6571A-08

S E R V I C E N O T E

**6571A - DC POWER SUPPLY, 0-8 V, 0-220 A, 1760 W.
MANUALLY CONTROLLED**

Serial Numbers: MY41000101/ MY41000215 SG41000101/ SG41000172

Situation:

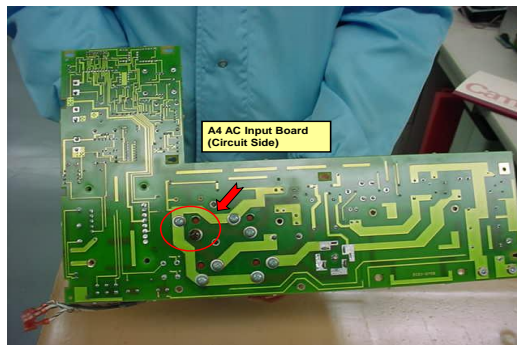
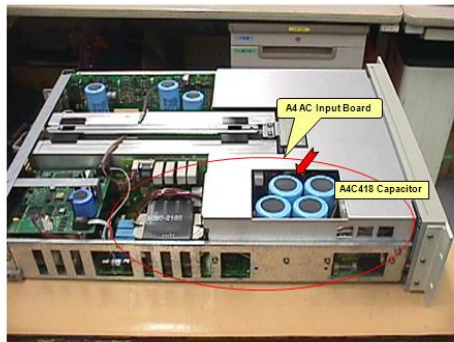
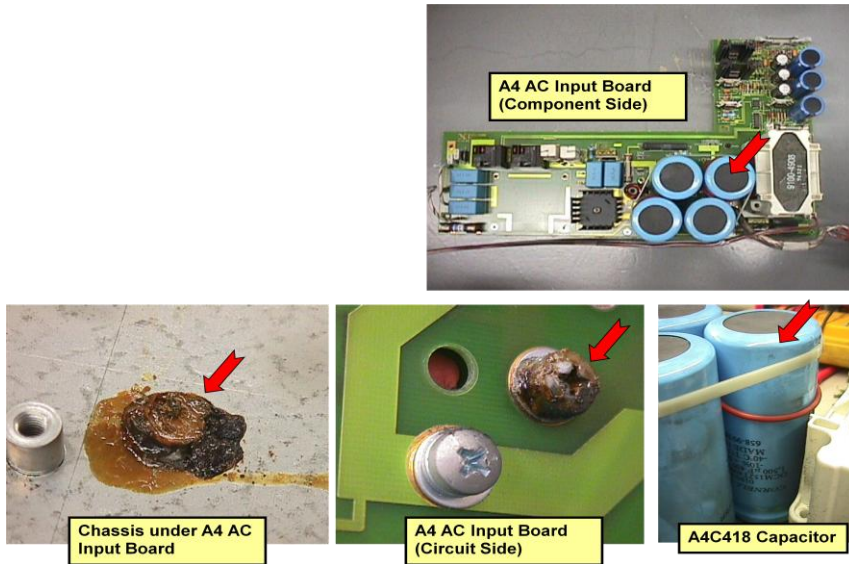
The four filter capacitors circuit reference (C416-C419) on the A4 AC input board starts leaking electrolyte - not through the pressure valve in the bottom as one would expect but through one of the terminal screw bushings.”

The screw P/N 2680-0217 length currently being used was not considered and the length was overlooked. The screw length is 0.375 inches long. We have found that the screw can be 0.055 inches too long and may bottom out causing the tapped hole in the header of the capacitor to become cracked or become broken.

When this happens the electrolyte will slowly leak out over time, and cause the defect described. This situation is even worse due to the capacitor is mounted with the header face down. If the capacitor was mounted header face up a cracked or broken header would not have caused this problem, the electrolyte could not leak out.

1. All affected models and tested assemblies WIP (Work In Process), FGI (Finished Goods Inventory) at SPO (Support Parts Organization) & AMC (Asian Manufacturing Center) has been inspected for capacitors with damaged headers due to the incorrect screw
2. When this repair is being done all of the hardware described above should be replaced (It is NOT recommended that any of the hardware be reused)
3. The following figures can be used when doing the repair.
4. Inspect the assembly as described below.
5. The last figure will aid in the reassembly of the hardware and the capacitors.
